**MITSUBISHI POWER-DISTRIBUTION
CONTROL EQUIPMENT
SALES & SERVICES**

NO.YAMA375

Indication change of the rating nameplate for mechanical indicators

(1) The accessories (GR-2/KR-1 multipliers)

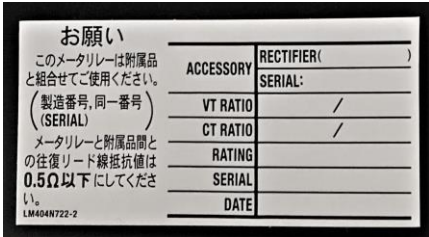
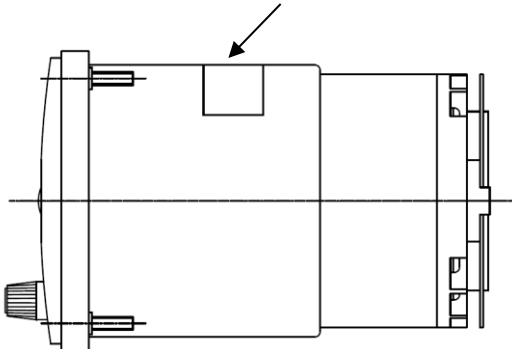
The rating nameplate will be expanded.

*The contents of the nameplate is not changed.

Before change	After change
<p><GR-2 multiplier> ·The size of the nameplate: 40 × 25</p> 	<p><GR-2 multiplier> ·The size of the nameplate: 55 × 26</p> 
<p><KR-1 multiplier> ·The size of the nameplate: 40 × 25</p>  <p>3-terminal</p>  <p>2-terminal</p>	<p><KR-1 multiplier> ·The size of the nameplate: 55 × 26</p>  <p>3-terminal</p>  <p>2-terminal</p>
